ARCHITECTURAL REVIEW AND PUBLIC FACILITIES DECISION

AR-15-0026

Project: Tualatin Animal Clinic Parking Lot Upgrades

Location: 8700 SW Cherokee St (Tax Lot 2S1 23AA 01000)

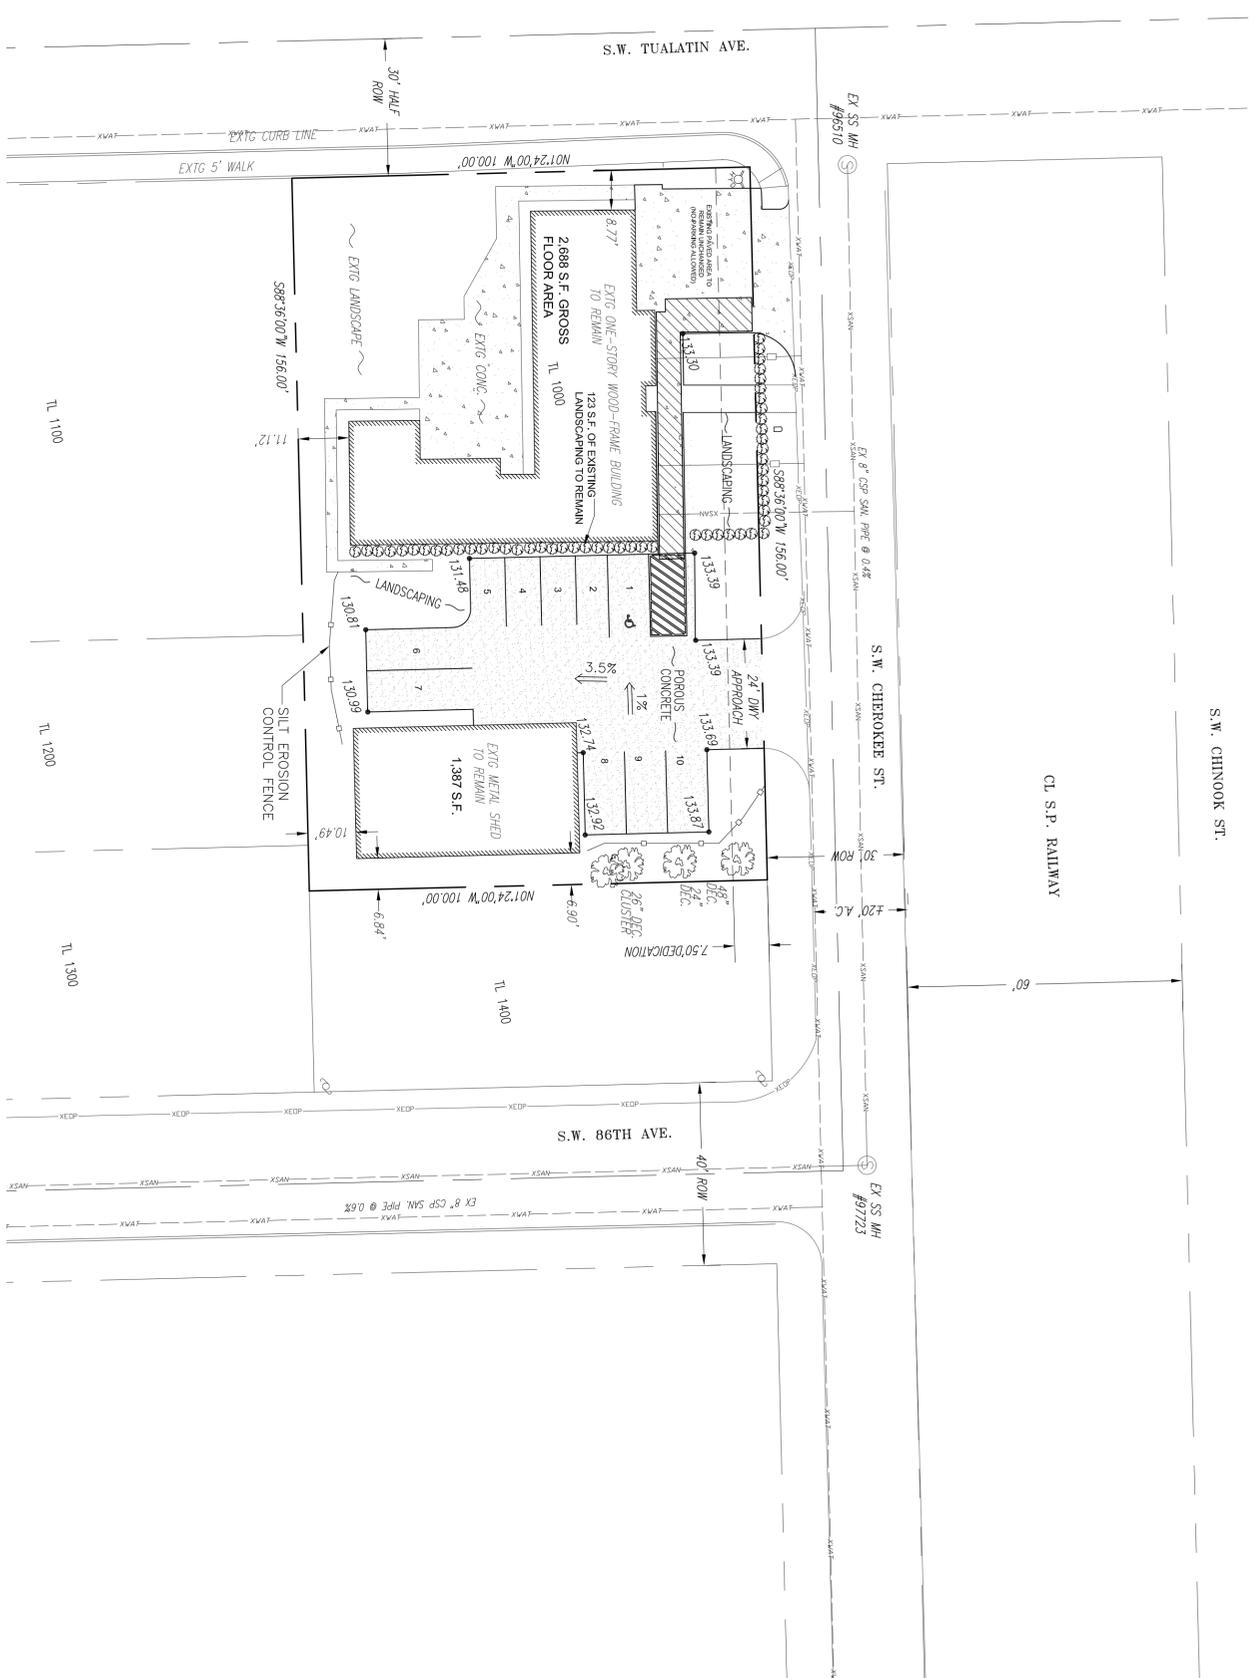
The transportation grading notes and the erosion control notes on Sheet 2 of 2 make several references to the City of Vancouver, the Vancouver Municipal Code and the State of Washington. These must be corrected.

Condition of Approval: Submit revised plans to refer to the correct jurisdictions.

SITE PLAN

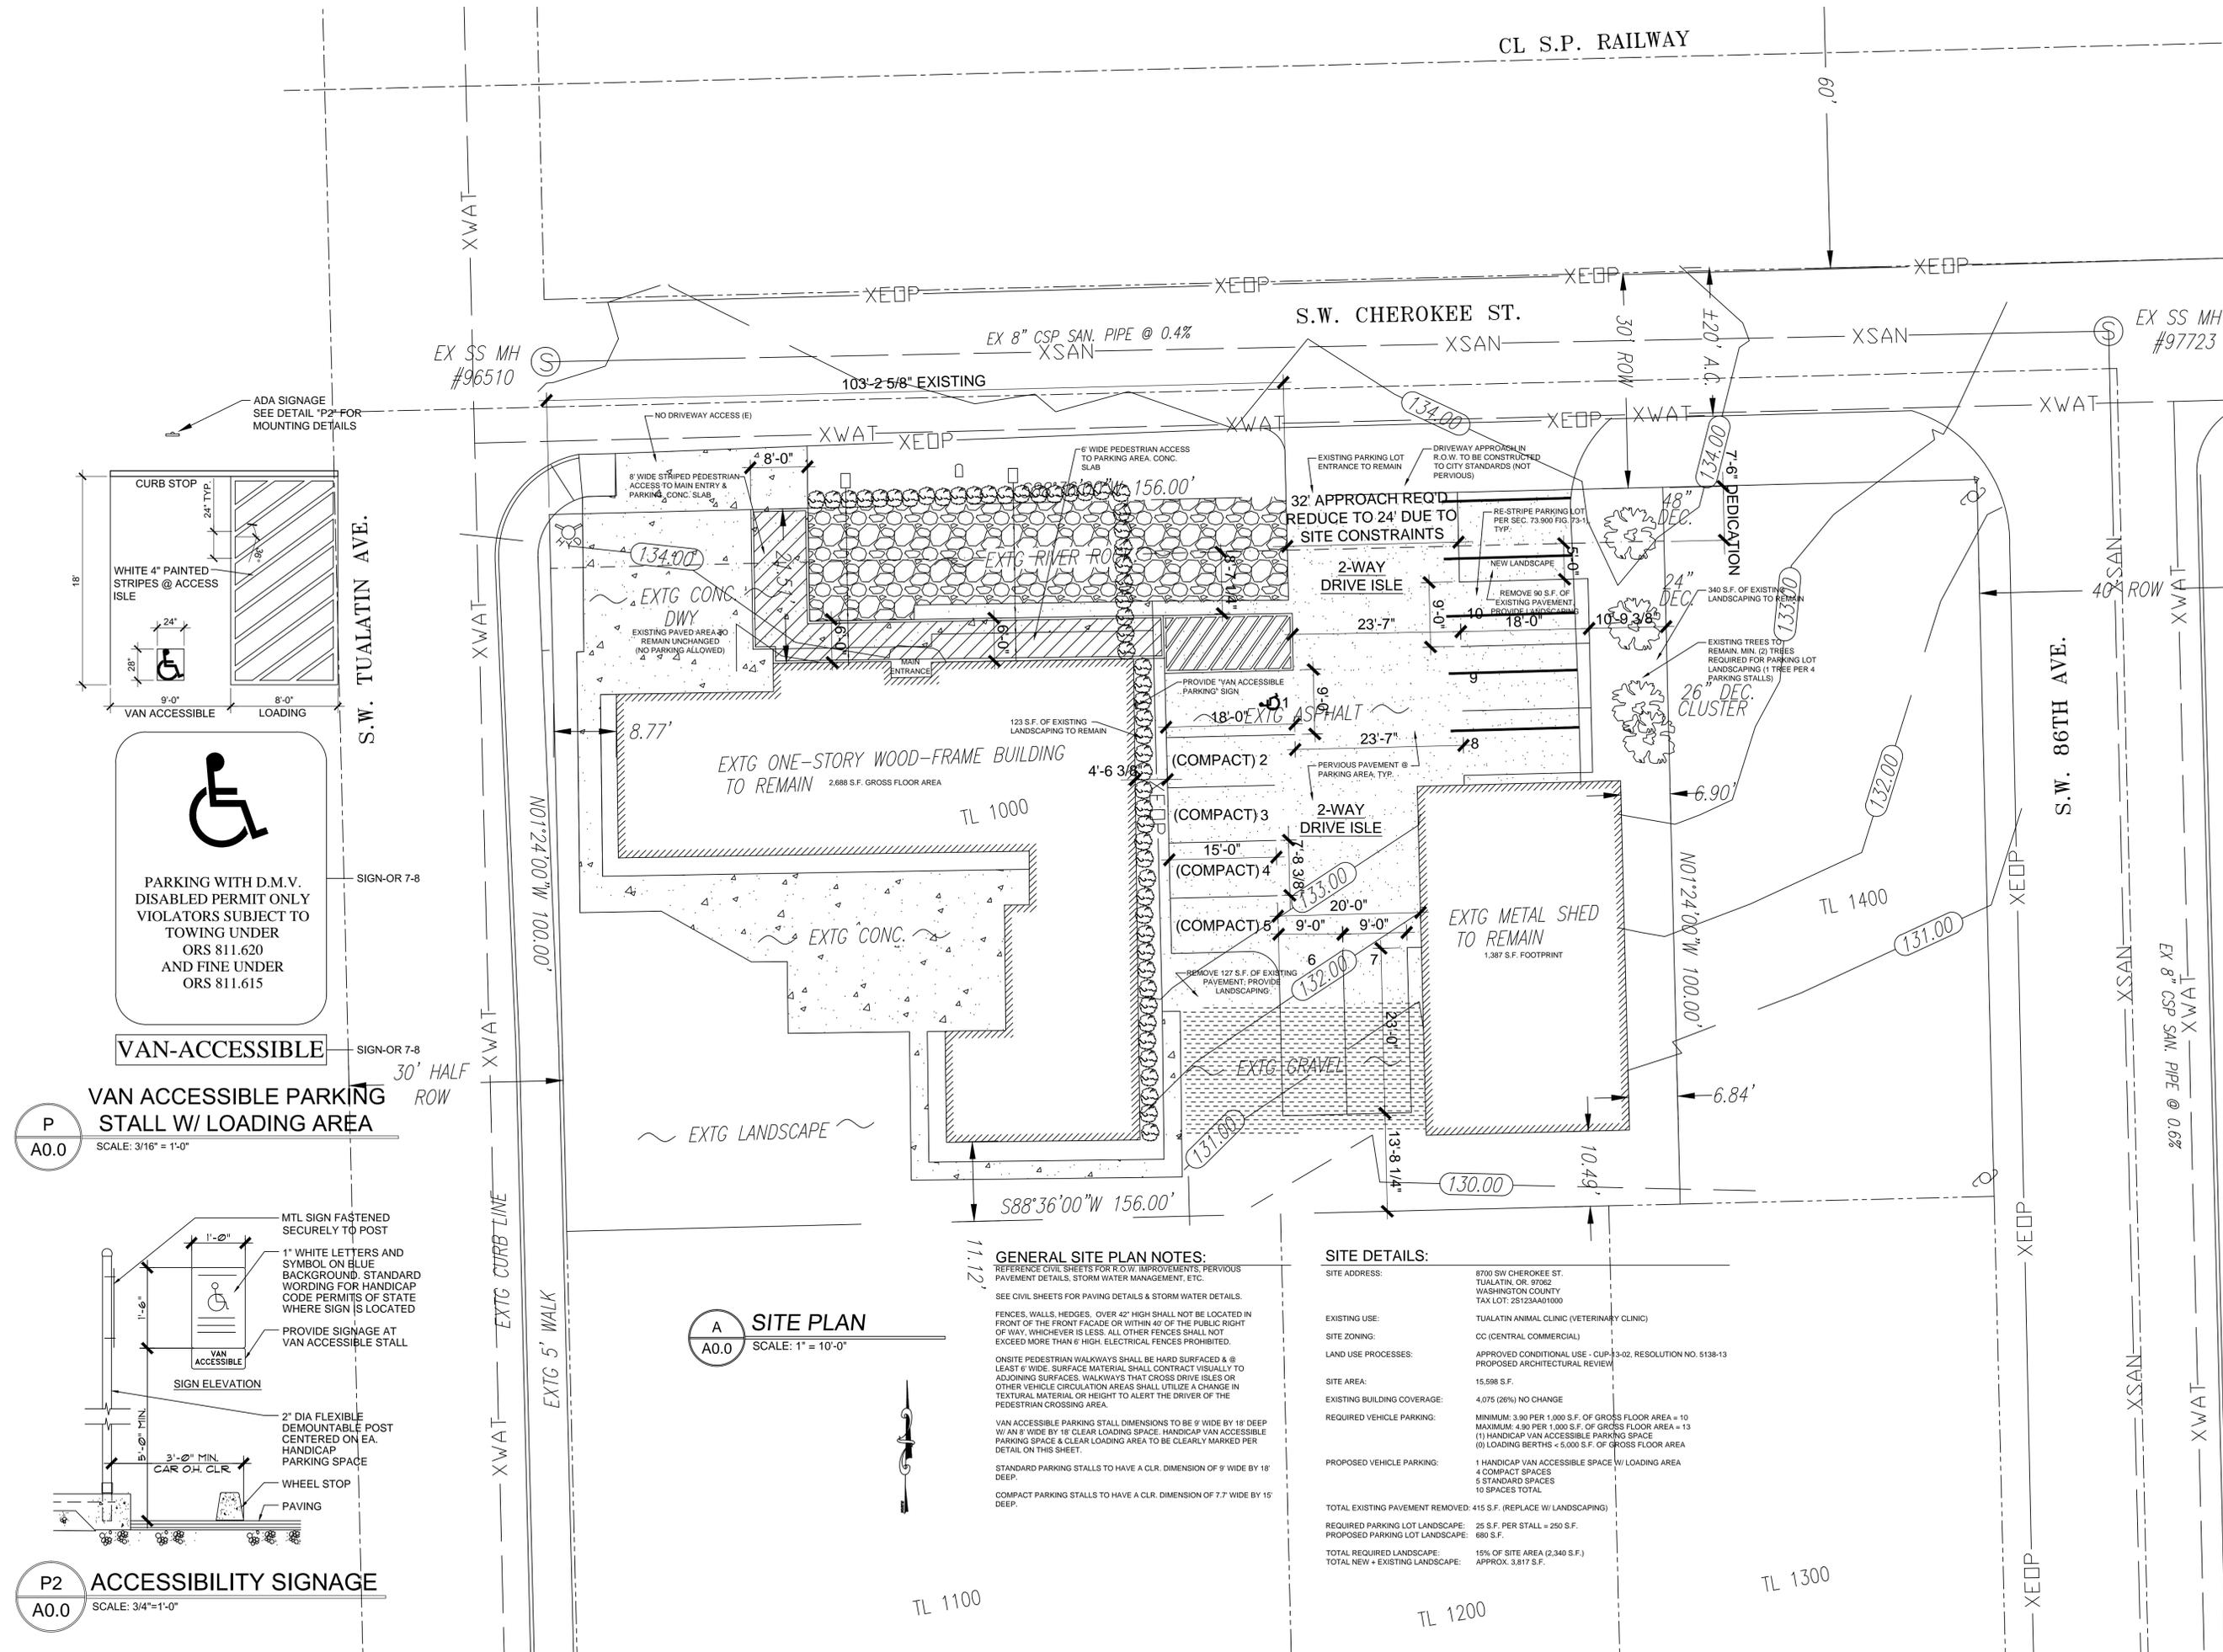
The required minimum setback is provided if measured on the plans with a scale, but it is not dimensioned or specified.

No existing or proposed parking area lighting is shown on the plans.

The application does not include a landscaping plan with all the information required on an approved plan. On either side of the entrance drive, no existing or proposed parking area landscaping materials and sizes are shown or specified on the plans. Therefore, staff requires the following:

The proposed plans provide enough automobile parking stalls to comply. However, no bicycle parking is provided.

The proposed parking plan does not provide the required vanpool and carpool parking stall.

No proposed parking bumpers or wheel stops or curbing are shown on the plans.

However, for safety the width of the access drive must be maximized given site constraints. The western side of the driveway approach may be moved to the west until it lines up with the end of the adjacent parking stall. The eastern side may be moved if the adjacent parking spaces take advantage of the 2.5-foot overhang illustrated in TDC Figure 73-1 (provided there is no interference with the existing trees). These are suggestions, but staff adds the following condition of approval:

Condition of Approval: Submit revised site plans adding a dimension line specifying an off-street parking and vehicular circulation area setback of at least the minimum 5 feet. The setback shall be provided or constructed to match approved plans.

Condition of Approval: Revise site plans to include existing and proposed parking area lighting. Such lighting shall be provided or installed in conformance with TDC 73.160(3)(c) and 73.380(6).

Condition of Approval: Submit, in addition to a revised site plan, a landscape and planting plan demonstrating compliance with site and landscape requirements specified in the Tualatin Development Code and demonstrating conformance with the relevant conditions of approval below.

Condition of Approval: Revise plans to provide at least two covered bicycle parking spaces Meeting the standards of 73.370 (n).

Condition of Approval: Revise plans to indicate a dedicated vanpool and carpool parking stall with sign.

Condition of Approval: Revise plans to include parking bumpers or wheel stops or curbing. Such barriers shall be in conformance with TDC 73.380(9).

Condition of approval: Revise plans to widen the S.W. Cherokee access drive to the greatest extent possible without compromising the parking area design or the integrity of the existing trees on the east side.
